ENVIRONMENTAL COMMITTEE MEETING

January 7, 2026

Subject: Review of redevelopment plans for 424 Butler Ave. E.

Review submitted plans for the redevelopment of the 424 Butler Avenue East property.

DRAWING N°
 C-5

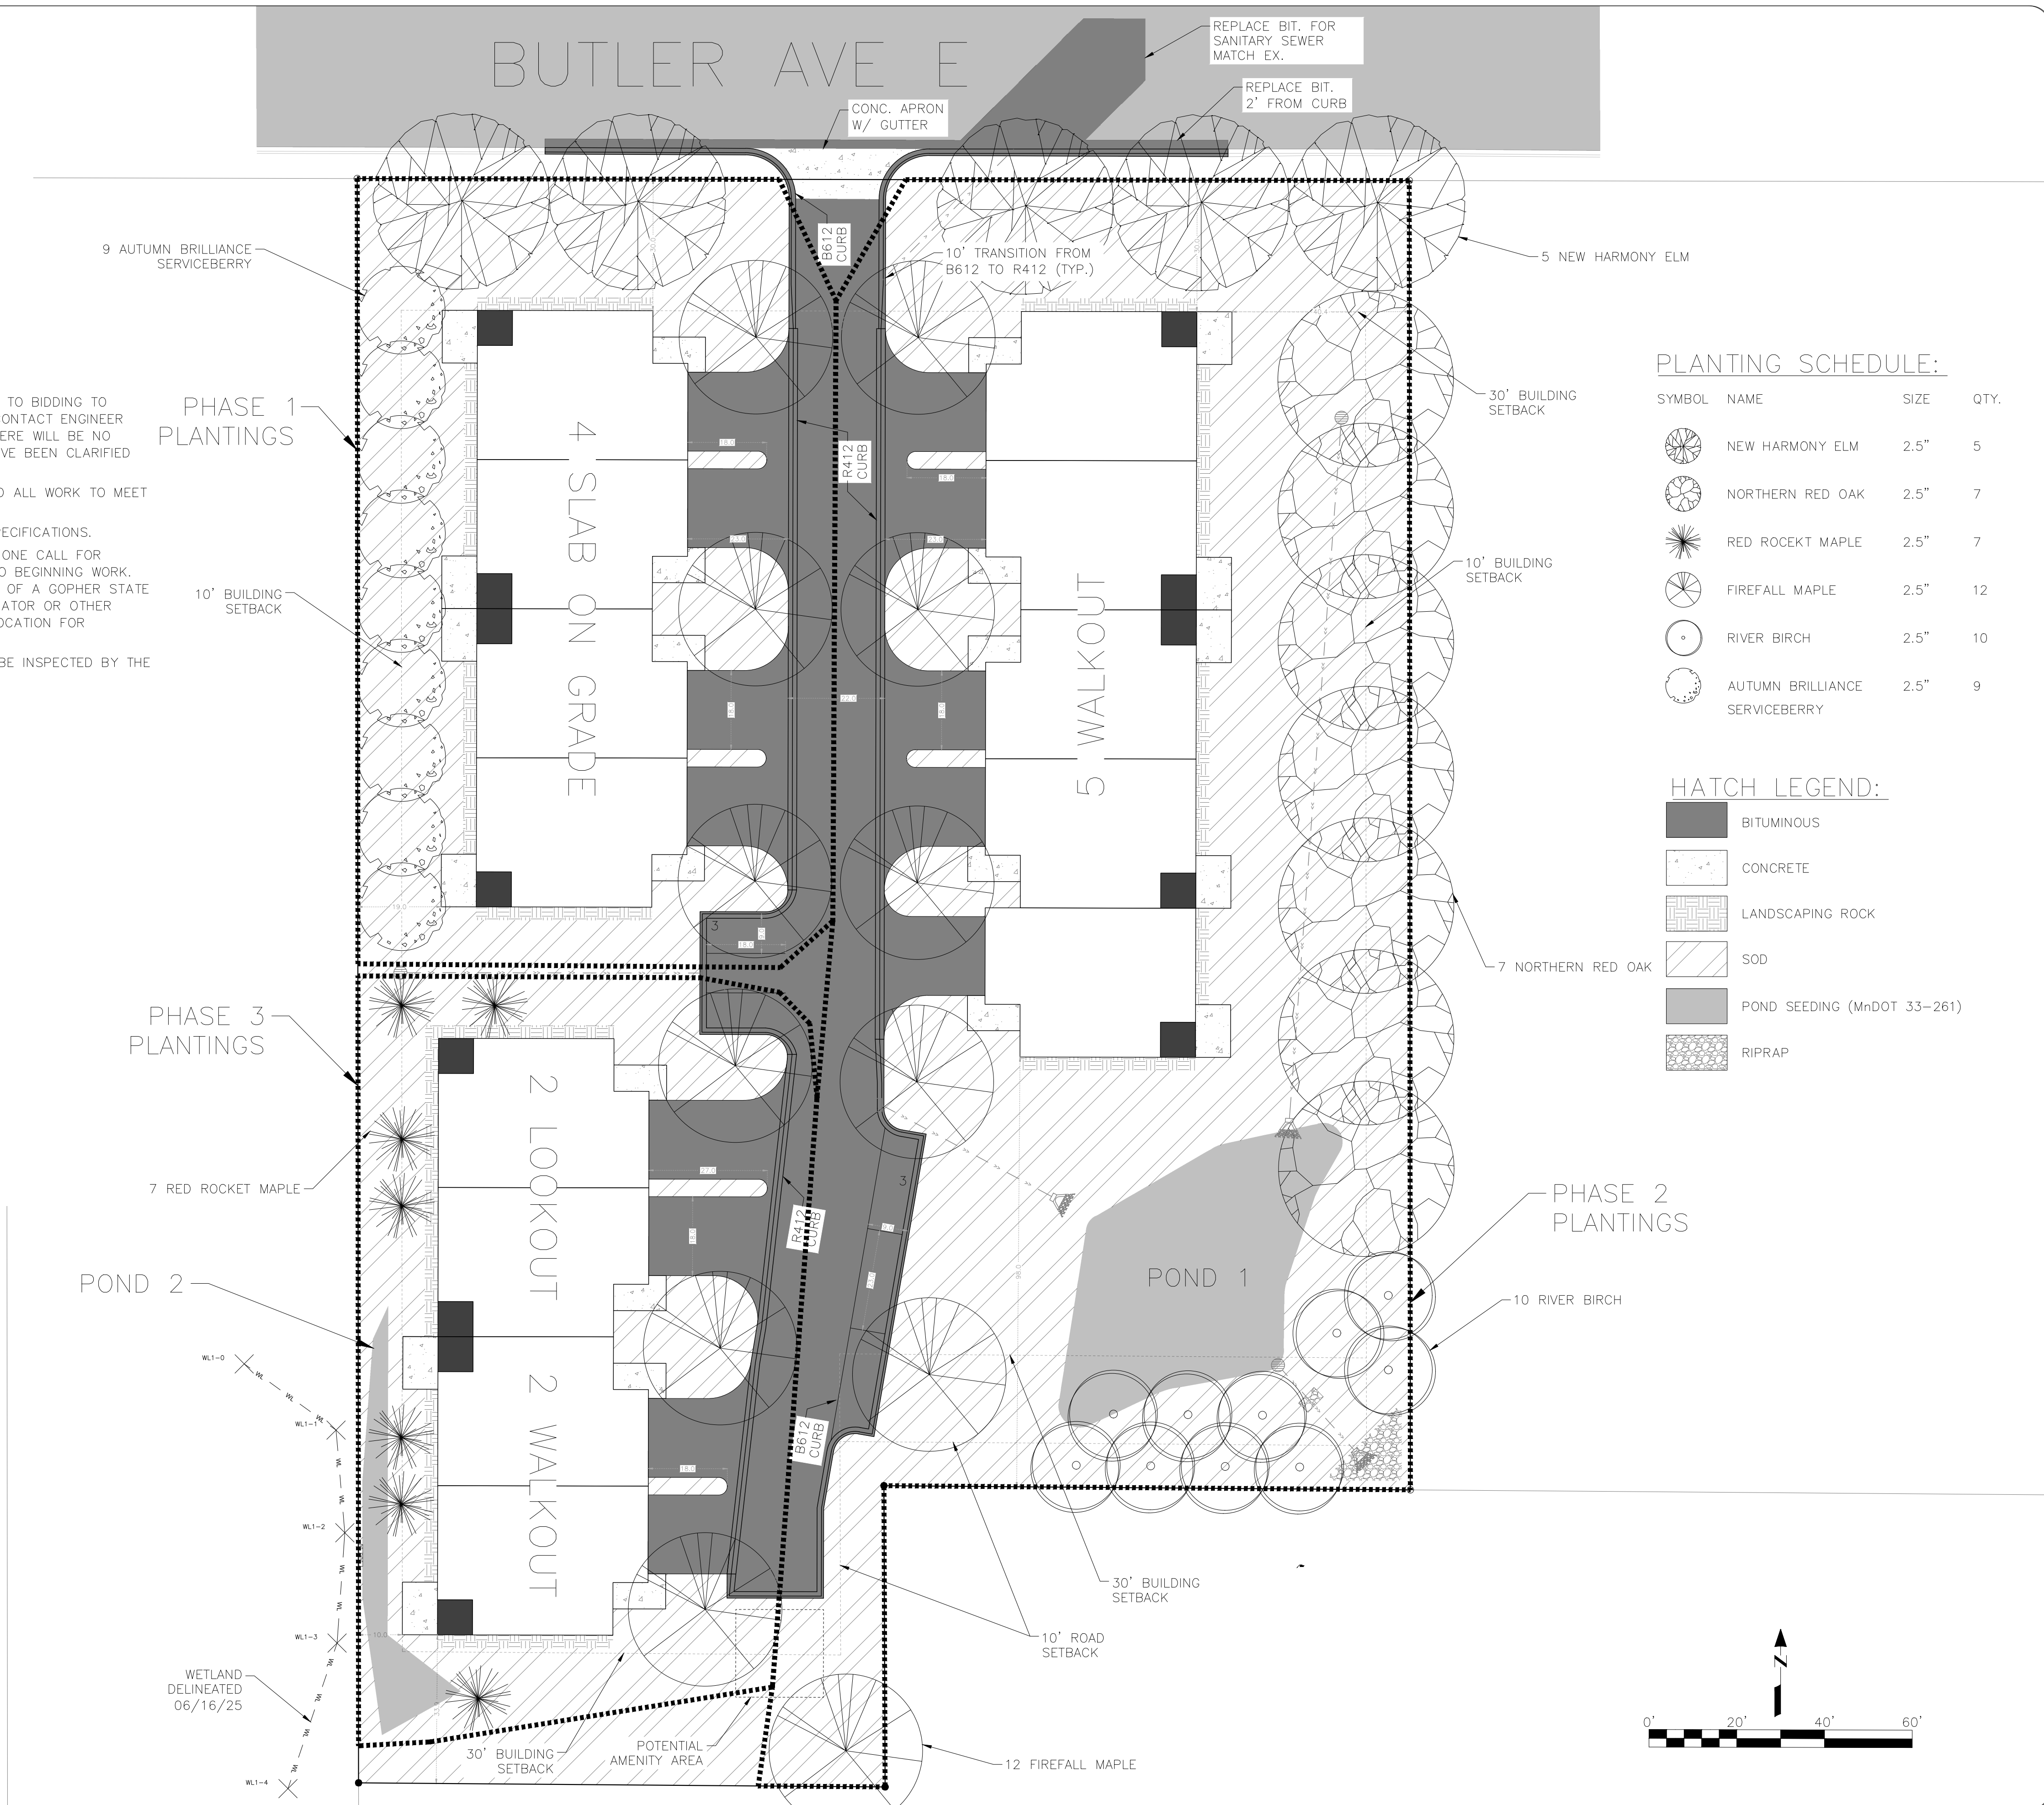
The list below includes the initial proposal for new plantings on the site. Staff has crossed out the initially proposed plantings (shown by the ~~double strikethrough~~) and added alternative plantings in red text as well as recommended additional plantings.

Staff is also recommending that the size of trees be increased from 2.5 caliper inches up to 3 inches. This brings the number of proposed trees/caliper inches for the site to 57 trees and 171 caliper inches. As these numbers fall below the minimum requirement (144 trees/359 inches), staff is requesting feedback from the commission on where additional trees might be planted as well as recommended types.

- All trees are to be increased in size from 2.5 caliper inches to 3 caliper inches.

- The seven Northern Red Oak trees are to be replaced with three Bur Oak and four Swamp White Oak trees.
- The seven Red Rocket Maple trees are to be replaced with three Common Hackberry and four Honey Lotus trees.
- The 12 Firefall maple trees are to be replaced with six Black cherry and six Little Leaf Linden trees.
- The plans shall include an additional seven Red Cedar trees.
